Subject: Exelon Nuclear Texas Holdings, LLC
Victoria County Station Early Site Permit Application
Response to Request for Additional Information Letter No. 09
NRC Docket No. 52-042

Attached are responses to NRC staff questions included in Request for Additional Information (RAI) Letter No. 09, dated May 6, 2011, related to Early Site Permit Application (ESPA), Part 2, Sections 02.05.01 and 02.05.03. NRC RAI Letter No. 09 contained twenty-three (23) Questions. This submittal comprises a partial response to RAI Letter No. 09, and includes responses to the following eight (8) Questions:

Figure 1. Color Shaded Relief Map of LiDAR Data Adjacent to the VCS Site Showing Location of Topographic Profiles.

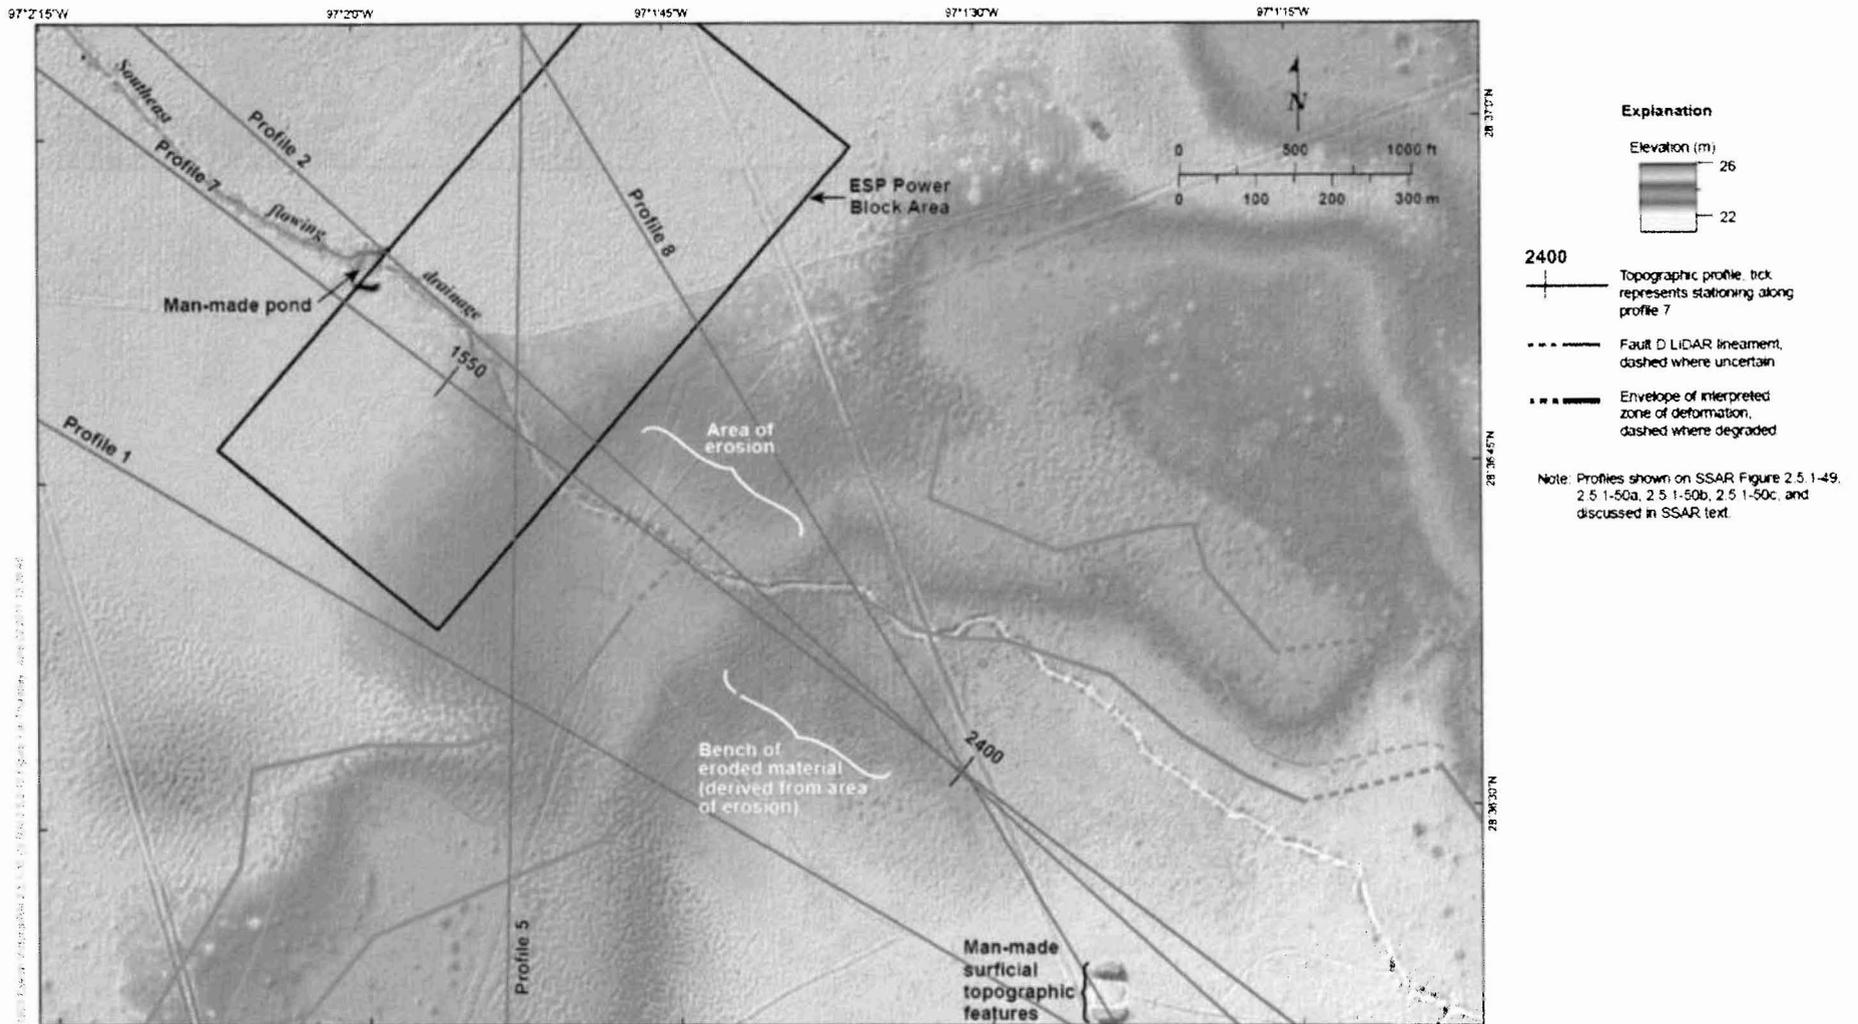
1. Please explain your justification for defining the boundary of the zone of deformation as the shaded triangle, as interpreted in the Figure 2.5.1-48, rather than the wider zone of deformation postulated above.
2. Please explain how you used the surficial topographic (LiDAR) data to define your interpreted zone of deformation. Also, please explain how the topography could be used to preclude the existence of a wider zone of deformation associated with fault D.
3. Please provide further justification for your interpretation that the lack of a topography break in LiDAR Profile 7 can be attributed to geomorphic or cultural processes rather than a wider zone of deformation between marker 1550 m southeastward to 2400 m, which encompasses the proposed location of Unit 1.

(3) As summarized as part of section (2) of this response, the zone enveloping the interpreted extent of tilting or folding associated with post-Beaumont activity of growth fault D was developed by analyzing a suite of over 90 LiDAR topographic profiles (SSAR Figure 2.5.1-49) rather than interpreting each topographic profile separately without regard to the overall local geomorphic/cultural setting. Figure 1 was developed to help illustrate the importance of the local setting when interpreting topographic profiles and to help answer the question posed by the NRC above. This figure illustrates the following:

The color shaded relief map of LiDAR data illustrates several important geomorphic features, including: 1) a southeast-flowing drainage (marked by a geomorphically distinct channel) through the power block area, 2) a series of small topographic bumps along the margins of the channel (suggest the channel has been deepened to improve drainage) and 3) a 'benched' area just south of the zone of deformation subparallel to the axis of the larger drainage (see SSAR subsection 2.5.1.2.4.2.3.2 for a detailed explanation of interpreted 'benched' areas).

As discussed in SSAR subsection 2.5.1.2.4.2.3.2, profile 7 runs through the middle of the southeast-flowing drainage that parallels a broad southeast-sloping topographic low, which has caused erosional degradation of the interpreted zone of deformation associated with growth fault D. In addition, profile 7 is located almost directly coincident with the distinct channel that has been anthropogenically modified near the southeastern and northwestern border of the power block area. The topographic expression of the zone of deformation is more distinct in profile 8, marking the eastern edge of the degraded zone in Figure 1. Likewise, comparison of profiles 7 (degraded) and profile 8 (distinct) suggest that erosion and 'benching' of profile 7 has occurred (see discussion of erosion and benching between profiles 7 and 8 in SSAR subsection 2.5.1.2.4.2.3.2 for further discussion). Thus, the most reasonable explanation of the topographic data is that the broad southeast-trending drainage has caused the muted expression of surface deformation associated with growth fault D along profile 7.
